**Walton County
The Grove**

**Change Proposal #13 – Building
G Lighting Permit Revisions**

Change Proposal #13 – Building G Permit Lighting Revisions

ON NORTH ELEVATION

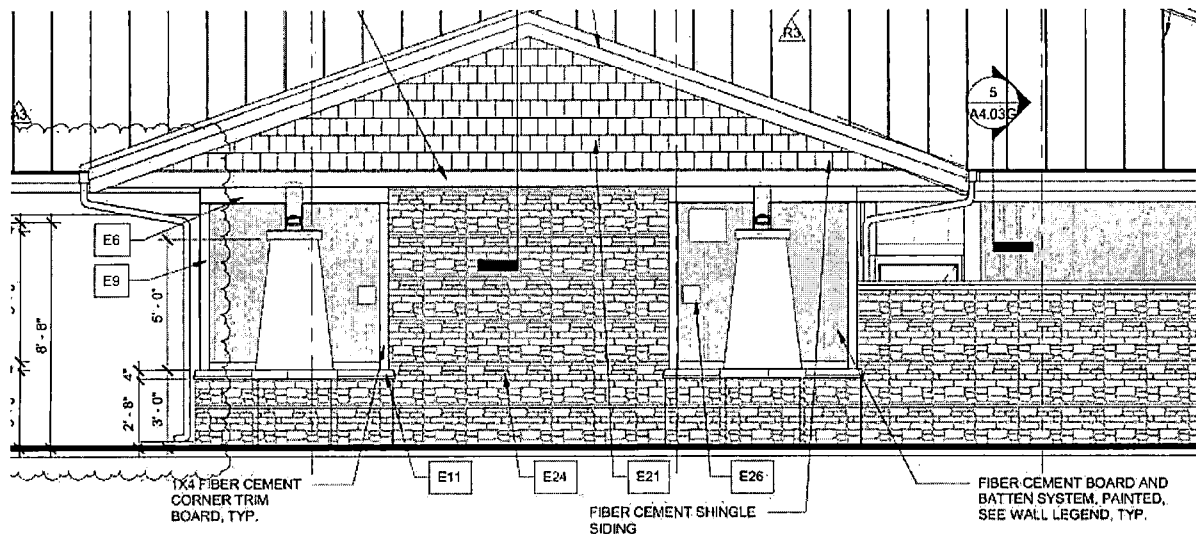
Thanks for taking my call. As discussed, the type of fixture change from OH to OC makes sense looking at architectural condition but I think there is a conflict between structural and the architectural column wrap. The depiction on 1/A3.01G shows what appears to match OC type mounting to a column above the column wrap but structural does not show these members. Without the column members, the wrap doesn't seem necessary. We are looking into this for a formal RFI, but it looks like the best option might be to remove the column wraps/bump out.
